AGENDA

ST. TAMMANY PARISH PLANNING COMMISSION MEETING 6:00 PM - TUESDAY SEPTEMBER 8, 2020 ST. TAMMANY PARISH GOVERNMENT COMPLEX PARISH COUNCIL CHAMBERS 21490 KOOP DRIVE, MANDEVILLE, LOUISIANA

2020-1975-MSP

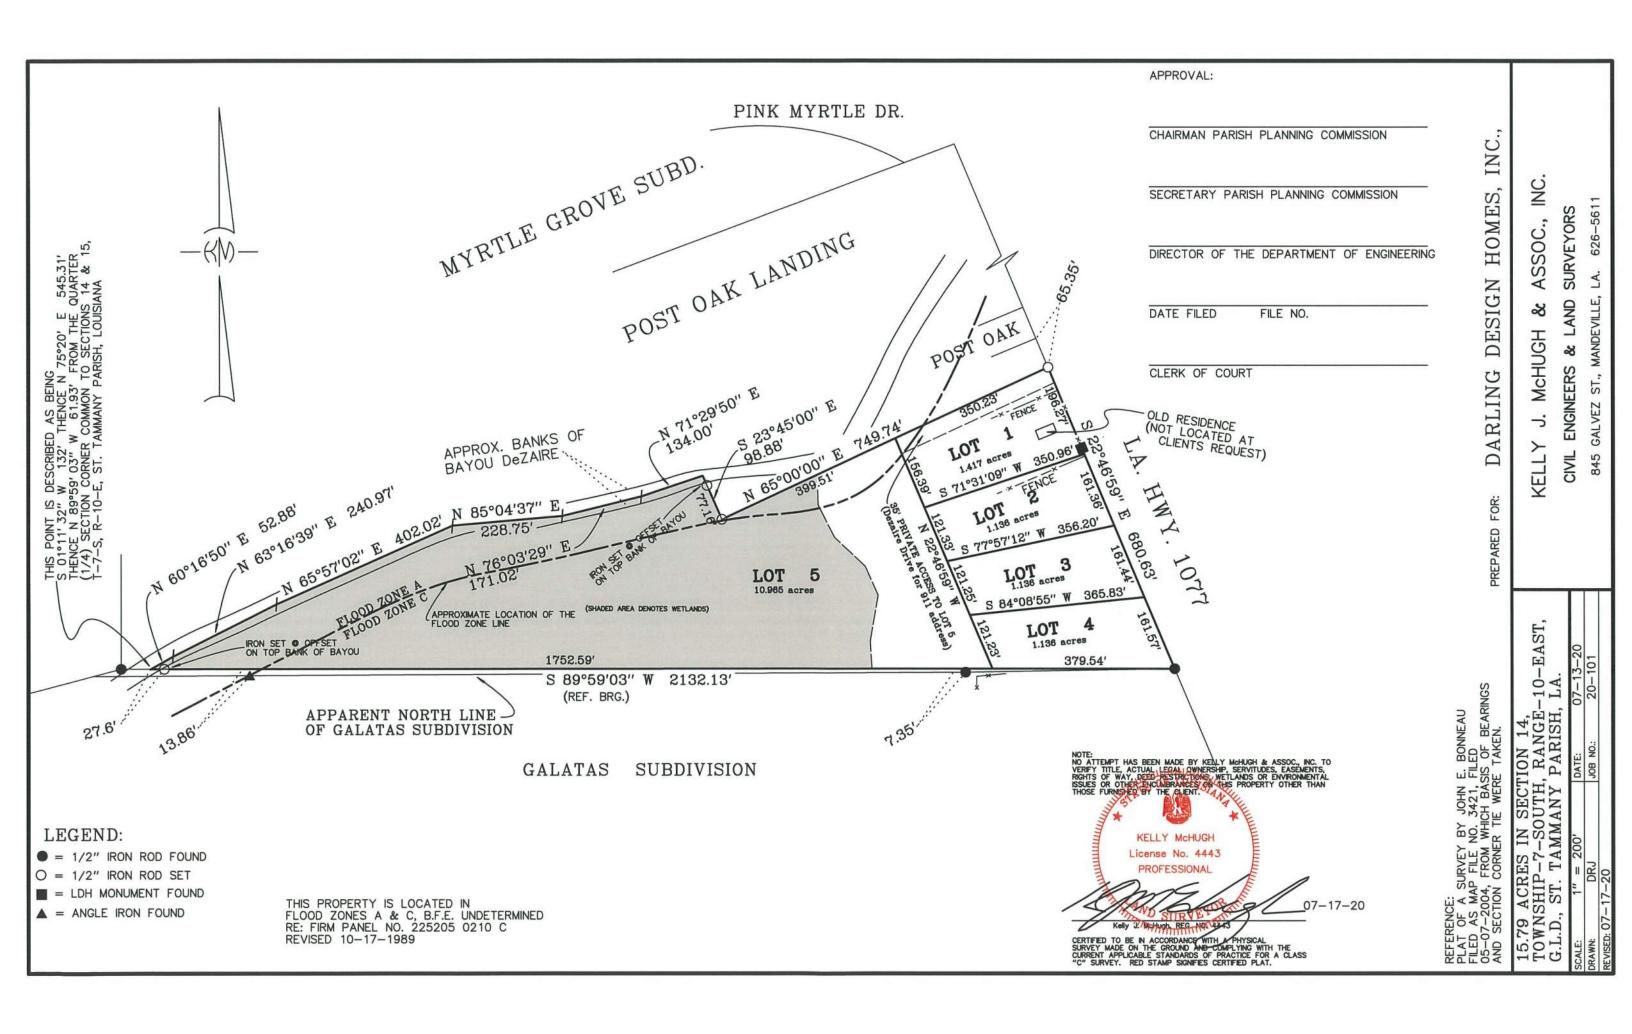
• Lot 1 not having public road frontage and being accessed via a 35' access servitude.

- 1. The survey should show "POST OAK LN".
- 2. The proposed name of the access depicted on the survey plat, shall be granted approval by the Planning Commission. As per St. Tammany Parish Communication District, the proposed name "DESAIRE DRIVE" causes issues. New access name "LOST BAYOU DRIVE" has been submitted and approved by St. Tammany Parish Communication District. Provide amended survey showing the new access name.
- 3. The survey should indicate: "A minor subdivision of 15.79 acres into lots 1, 2, 3, 4 & 5".

2020-1996-MSP

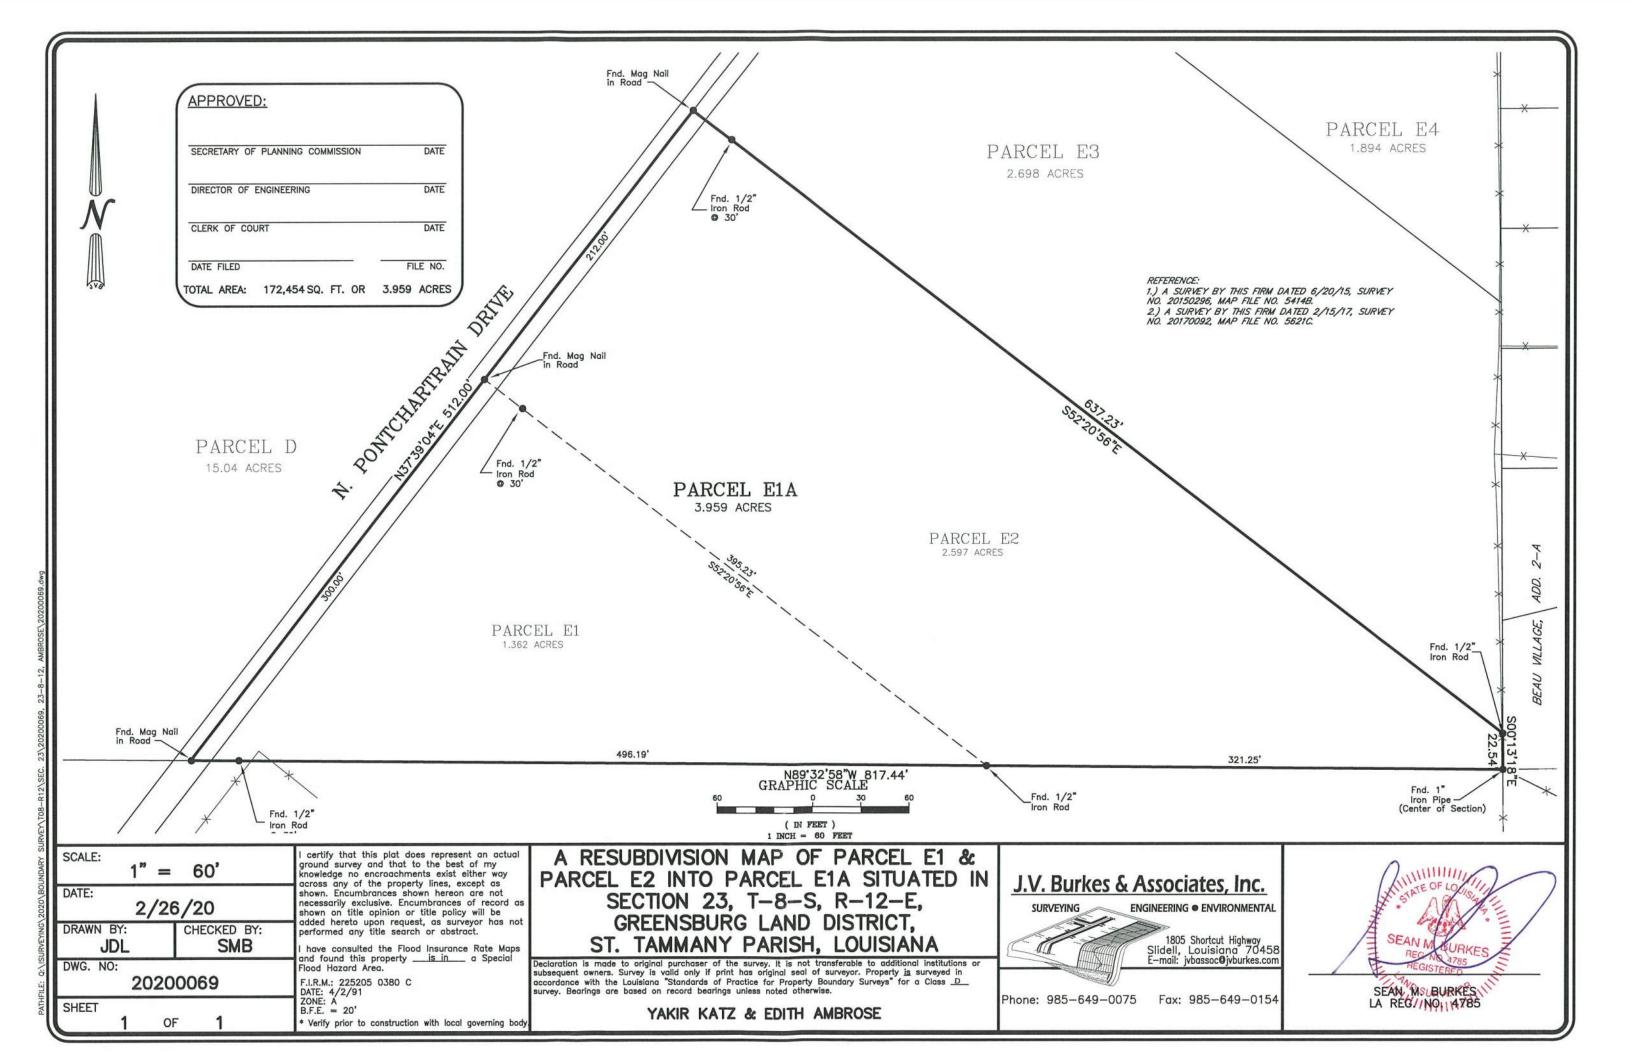
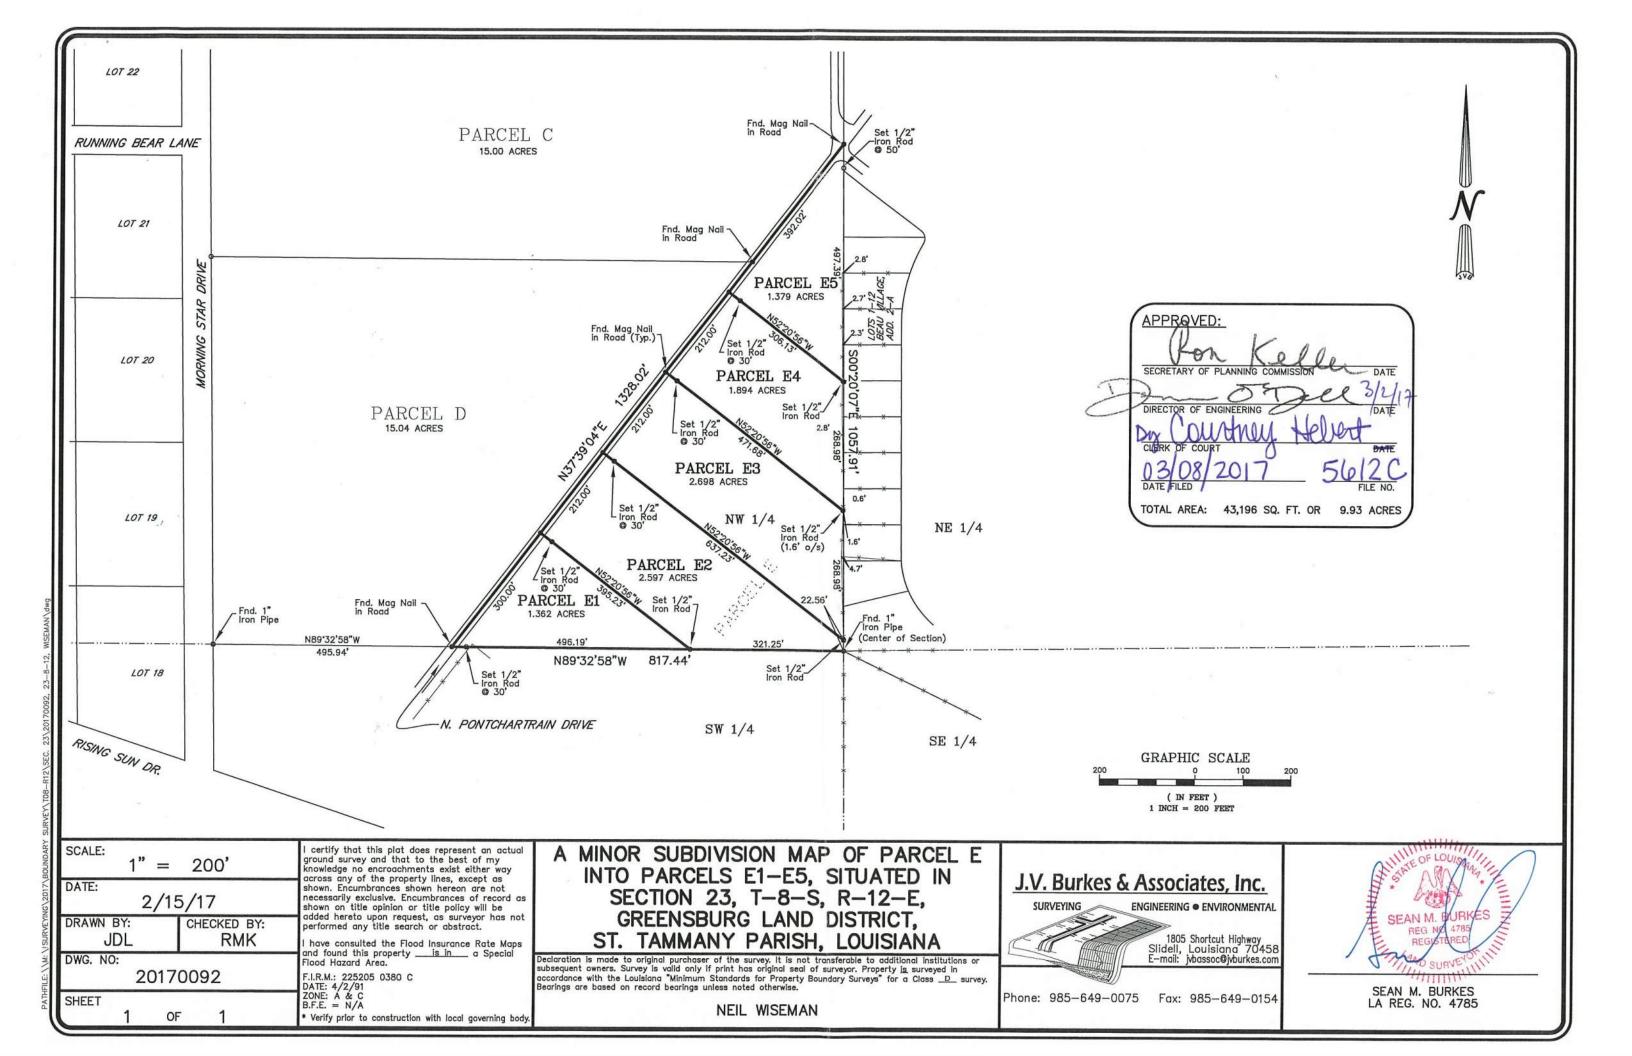
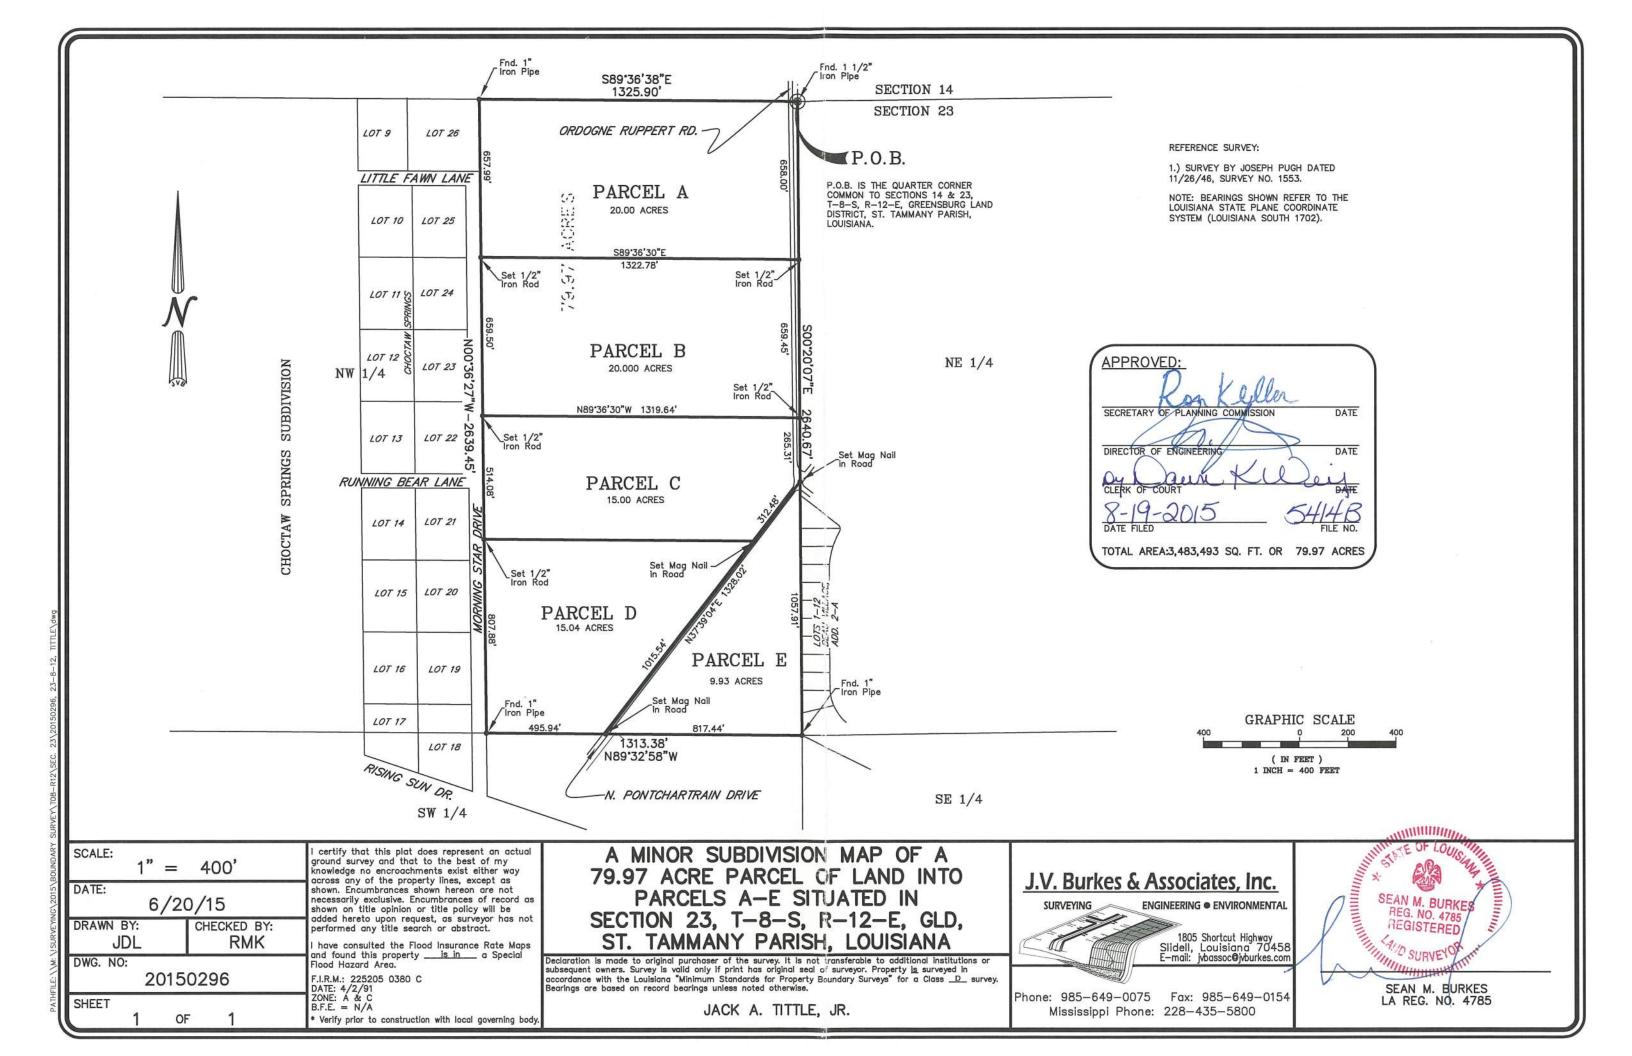
- 1. The plat must be amended to include a signature line for the Chairman of the Planning Commission.
- 2. Provide the dimension of N. Pontchartrain Drive Right of Way, dedicated to the Parish.
- 3. Add Note to the Survey: Front yard setback shall beginning at the edge of the asphalt Parish Right of Way.

2020-2022-MSP

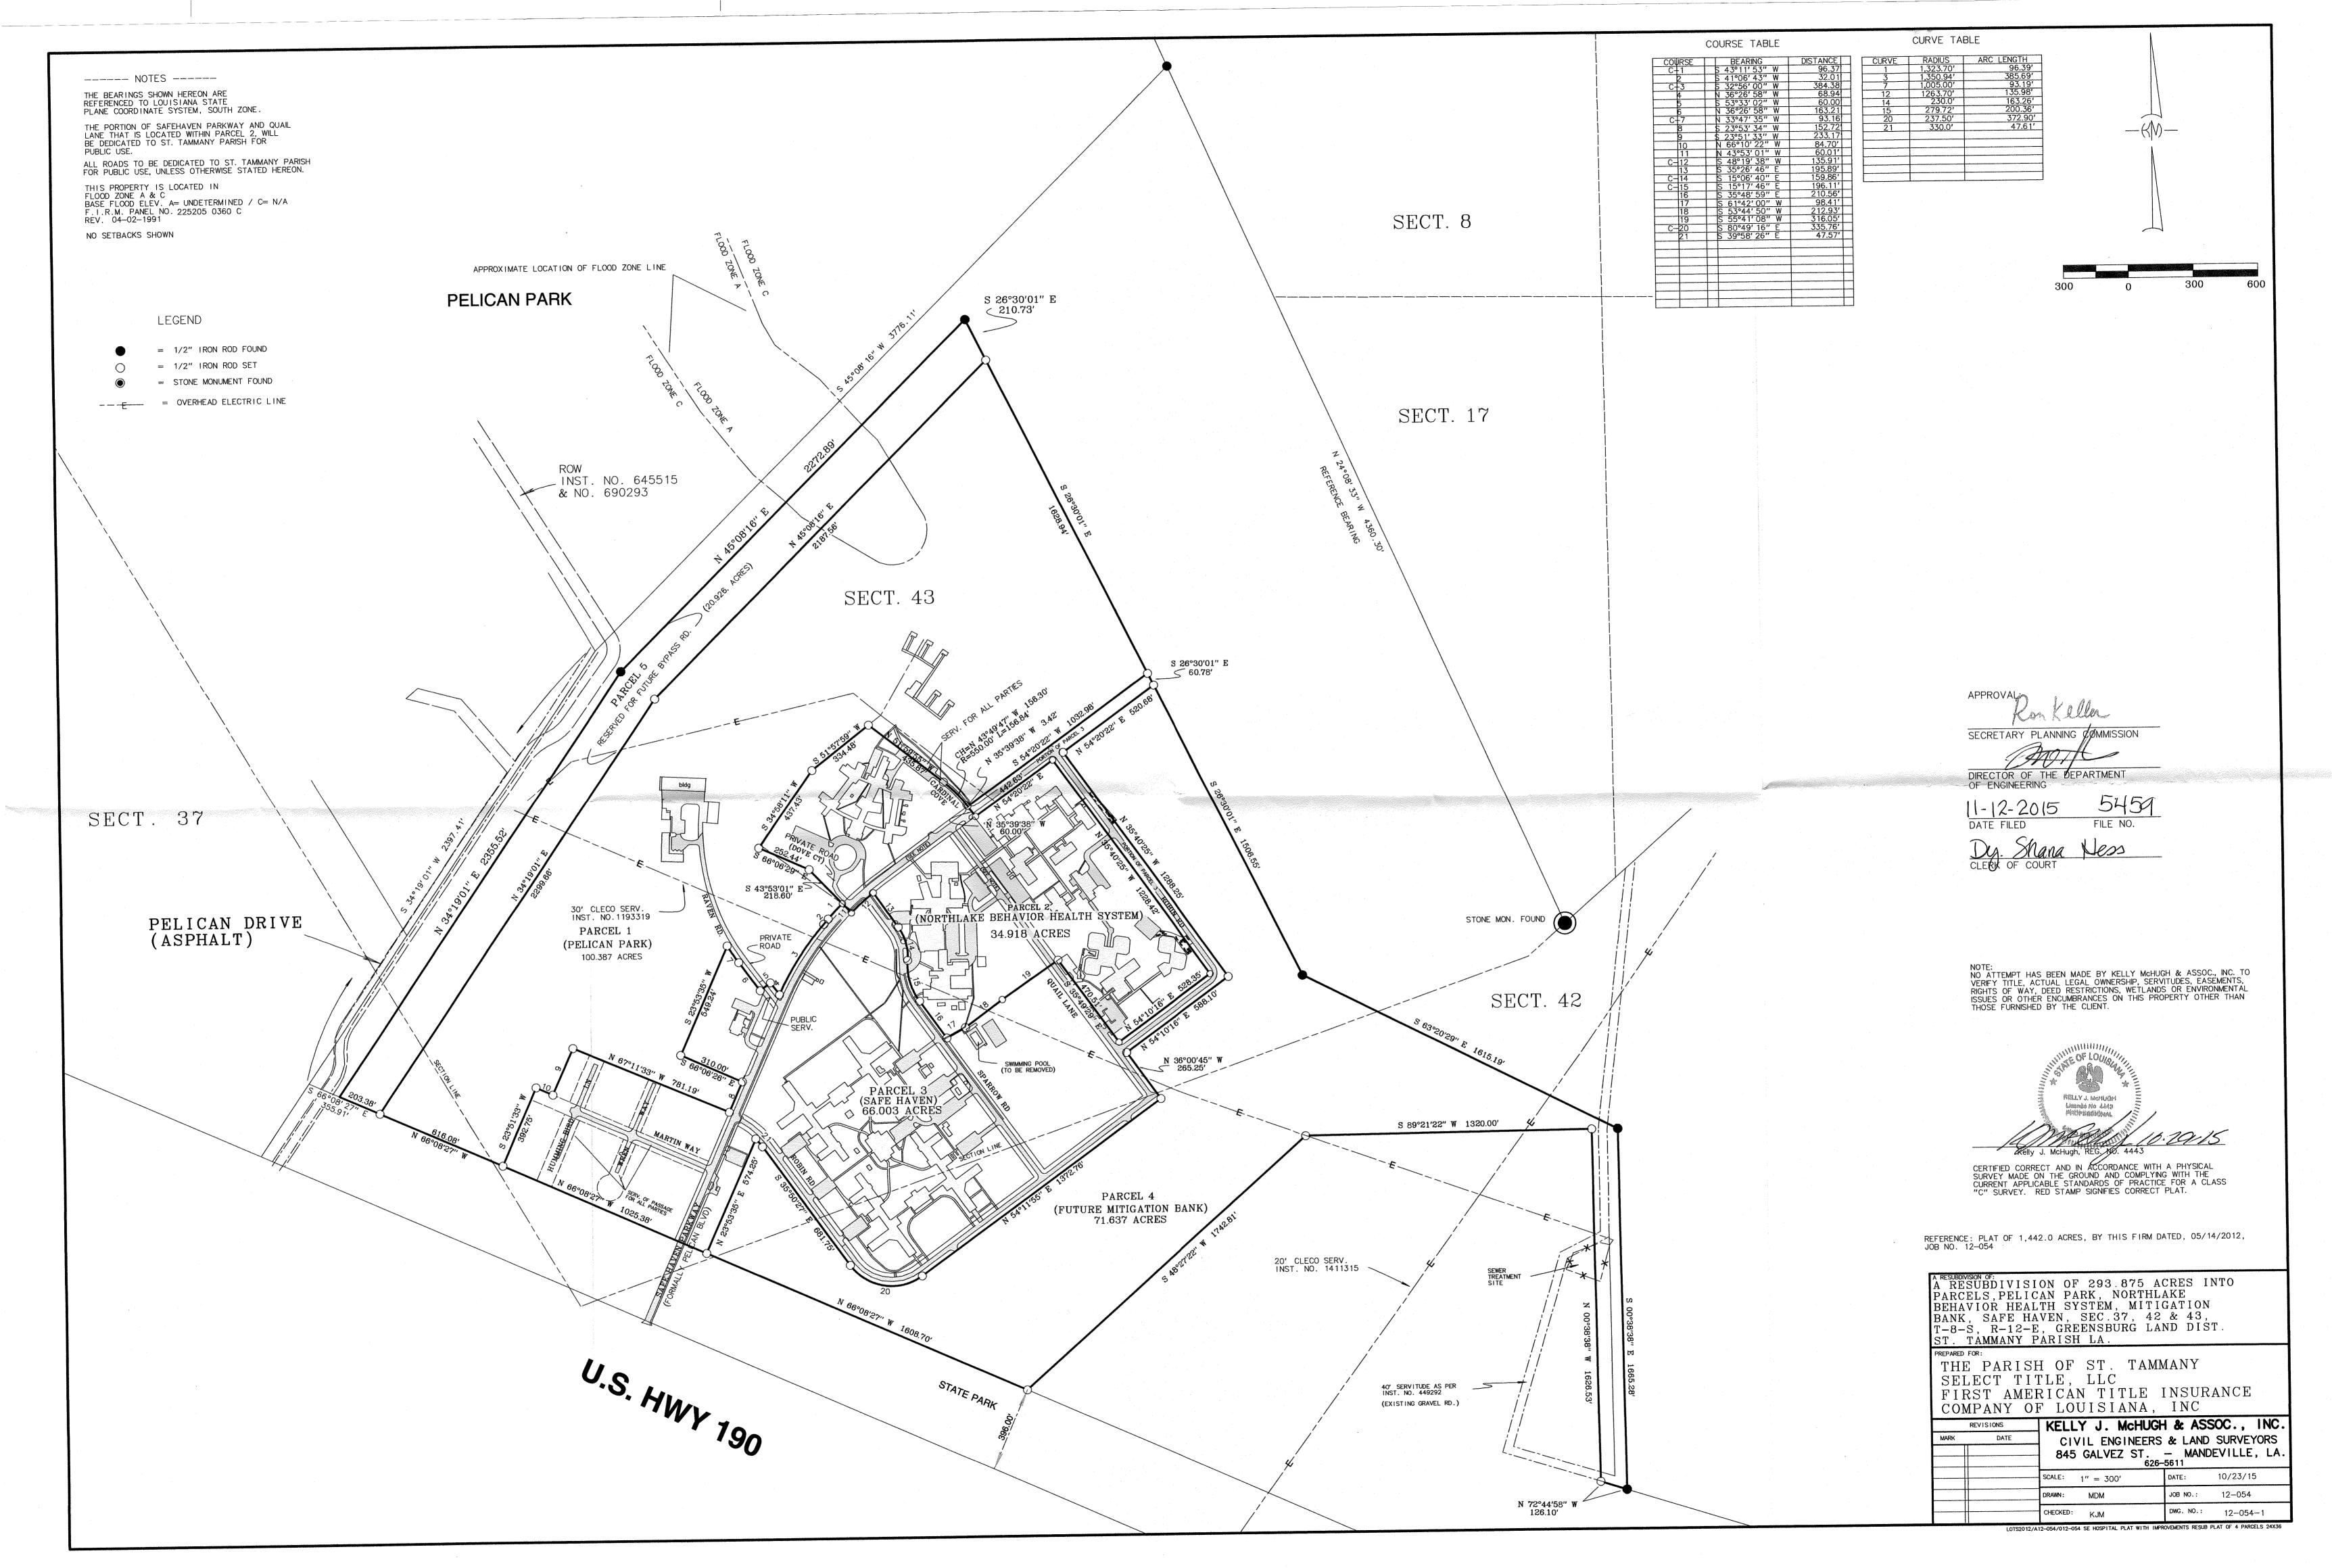
- 1. The plat must be amended to include a signature line for the Chairman of the Planning Commission.
- 2. The roadway identified as "PELICAN DR" should read "PATRICIA P BRISTER SAFE HAVEN PKWY" and the roadway identified as "EX 60' SERVITUDE" SHOULD READ "MARTIN WAY"
- 3. The following roadways shall be identified on the survey: "DOVE CIR", "HUMMINGBIRD LN" and "WREN WAY".
- 4. Amend the survey as follow: A RESUBDIVISION MINOR SUBDIVISION OF 100.387 ACRES BEING PARCEL 1 INTO PARCELS 1-A & 1-B...
- 5. Identify Parcel 1 on the survey.
